Reference No. 06623099-698-L-Rev1

**PASMINCO COCKLE CREEK SMELTER:  
PROPOSED DESIGN CHANGES FOR CONTAINMENT CELL CAP**

Figure 1: Concept of proposed geocomposite capping system

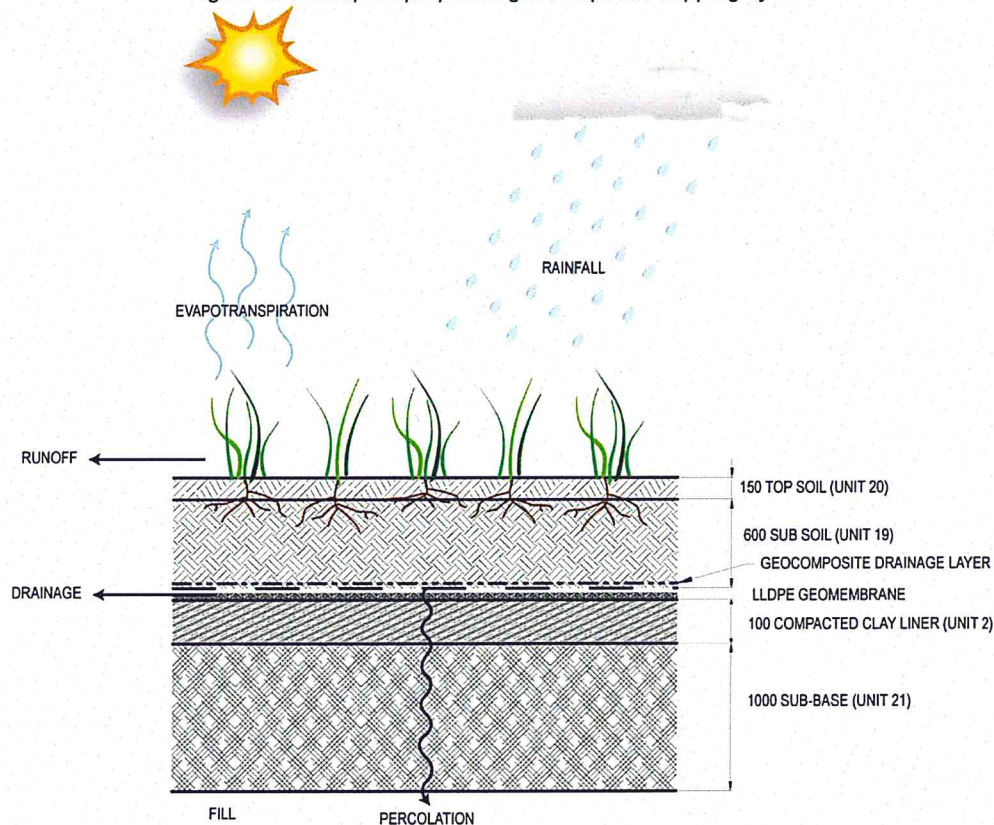
The current capping system design for Cell 1 and proposed design revisions are identified in Table 2 below and discussed subsequently. Revisions are proposed for the drainage layer and barrier layer components. The proposed design revisions apply primarily to the portions of the capping system on the top deck of Cell 1 that have not yet been constructed.

The following figure shows the revised design proposed for the capping system for the top deck of Cell 1.

The proposed design revision replaces a relatively thick layer of Unit 2 Clay with a thin layer of Unit 2 Clay overlain by a geomembrane. In the proposed design the thin layer of Unit 2 clay provides a bedding layer for the geomembrane that serves two functions as follows: (i) clay layer will protect the geomembrane because it will not contain any gravel or rock particles that could puncture or penetrate the geomembrane; and (ii) clay layer in contact with the geomembrane provides a composite liner effect whereby the rate of water leakage through any defects in the geomembrane is likely to be significantly less than if the geomembrane was placed on more permeable soil. Because the development of a full composite liner effect (i.e., an order of magnitude or more reduction in leakage rate) is typically documented for clay layers that are substantially thicker than 100 mm, we consider that only a partial composite effect will likely be achieved with the proposed design. However, even a partial composite effect would result in leakage rates several times lower than for a single clay liner or single geomembrane. On this basis alone, it can be demonstrated that environmental impacts caused by infiltration through the proposed cap are likely reduced from the cap design which is currently approved, assuming that the cap is maintained suitably as per the maintenance requirements.

The proposed design revision for the top deck of Cell 1 includes replacement of a 150 mm thick gravel drainage layer with a 5 to 10 mm thick geocomposite drain (i.e., a geonet drain core with geotextile filter bonded to both sides). Geocomposite drains are often used in conjunction with geomembranes in geosynthetic capping systems. Advantages and disadvantages of geocomposite drains are discussed in the table below.

Component (listed from top to bottom)	Existing Design	Proposed Design
Topsoil Layer	150 mm thick; Topsoil specification (Unit 20)	No change proposed
Subsoil Layer	600 mm thick; Subsoil specification (Unit 19)	No change proposed
Drainage Layer	150mm thick; Subsoil gravel drainage layer specification (Unit 18); Overlain by filter geotextile (Unit 13)	Geocomposite drain (geonet drain core with geotextile filter bonded to both sides); thickness 5-10 mm.
	Subsoil drainage collection pipes (Unit 17) within subsoils drainage layer	No change proposed to pipe material; revised pipe layout and spacing
Barrier Layer	no geomembrane	LLDPE geomembrane (overlying clay liner); thickness 1 mm
	600 mm thick; Clay liner material (Unit 2)	100 mm thick; Clay liner material (Unit 2)

Component (listed from top to bottom)	Existing Design	Proposed Design
Sub Base	1000 mm thick: Sub base material (*select Unit 21)	No change proposed
Total System Thickness	2500 mm	1860 mm
